Acoustic Review Report

For: Mollett's Farm

Report Reference: B5393 2021-05-11 R

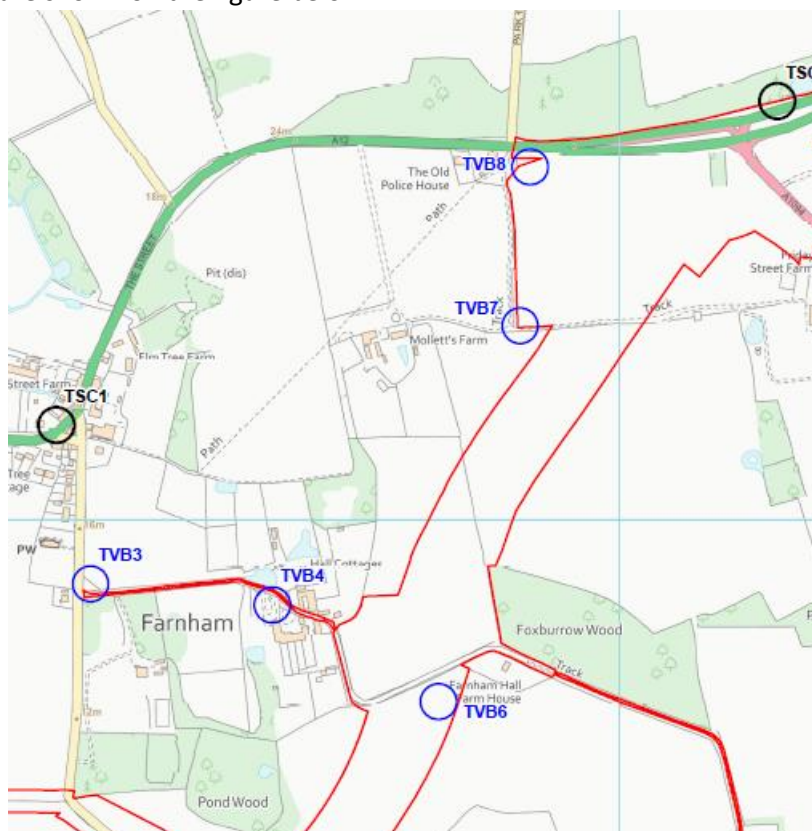
- 5.6 Two of the nine locations were relatively close to Mollet’s Farm, TVB7 and TVB8. The locations of which are shown on the figure below.

- 5.8 Based on experience of similar locations, and the reports of the guests at the holiday cottages, these levels seem high, particularly those at TVB7. A quiet rural location would typically have sound levels lower than these.
- 5.9 Individual pages giving details of the measurement at each location are included in the annexes to Vol 2 App 11A. For TVB7 and TVB 8 the information provided was as follows.
- 5.10 TVB 7 Mollett's Farm, was on a public footpath east of the farm, and was surveyed on 15 May 2019. The survey notes in the baseline report were:

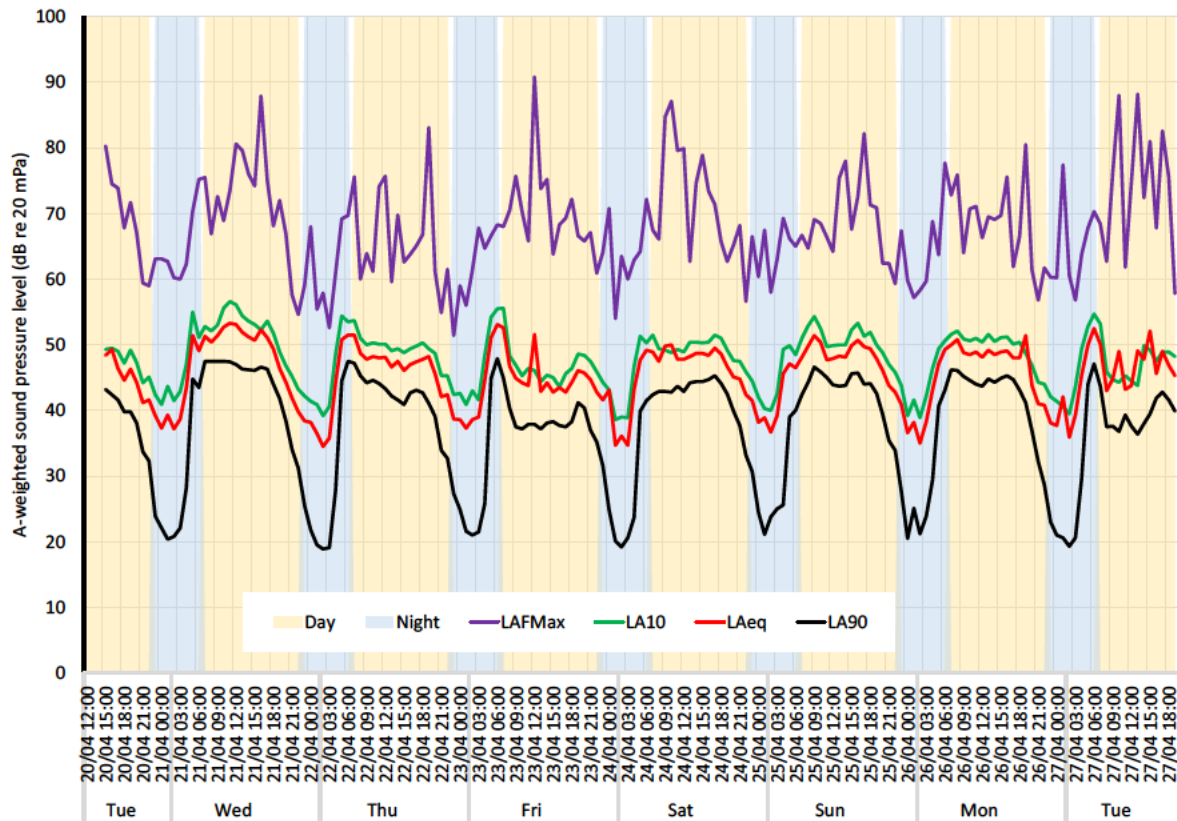
5.17 This gives a difference between upwind and downwind of the same source of 12 dB. The A12 is a significant source of Ambient sound at Mollett’s Farm. Therefore, without information on the wind conditions present during the monitoring surveys there is no way of determining whether the measured levels are representative.

5.18 As part of this review ACC has undertaken a series of measurements at location in the garden to the south of the house and holiday homes. This location was chosen to reflect the area were the family and guests tend to congregate when outdoors. This was more representative than TVB7, which is to the east of the farm.

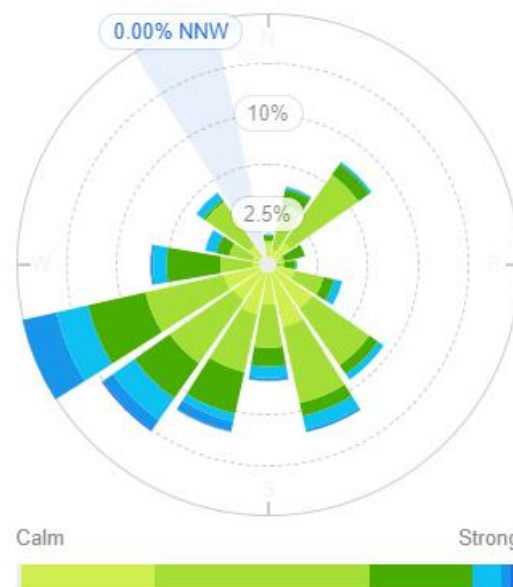
5.23 The loudest time of the day or night was generally the period between 05:00 and 07:00. Examination of the frequency analysis information stored with the data revealed a frequency content consistent with bird song. This was therefore caused by the dawn chorus. As this is a seasonal and natural part of the tranquil environment these periods were excluded from a determination of representative levels.

- 5.25 The wind speeds and directions in the area were logged throughout the measurement period. For example, on Friday 23rd the wind was from the east and south east, which would be generally unfavorable conditions for propagation of sound from the A12. On Monday 26th the wind was from the north east, which would be more favorable conditions for propagation of sound from the road. The residual sound level during the day on the 23rd in periods unaffected by the dawn chorus or aircraft was in the range 43 to 46 dB L_{Aeq} . On the 26th the residual levels were 48 - 49 dB L_{Aeq} . Similarly, the L_{A10} levels were between 45 and 48 on the 23rd and 50 and 52 on the 26th.

- 5.26 At night, before the start of the dawn chorus, residual sound level consistently dropped to 35 to 37 dB L_{Aeq} .
- 5.27 The relocation of the A12 from the north of the farm to the south will have a major impact on the conditions under which the noise propagates from the road to the property.
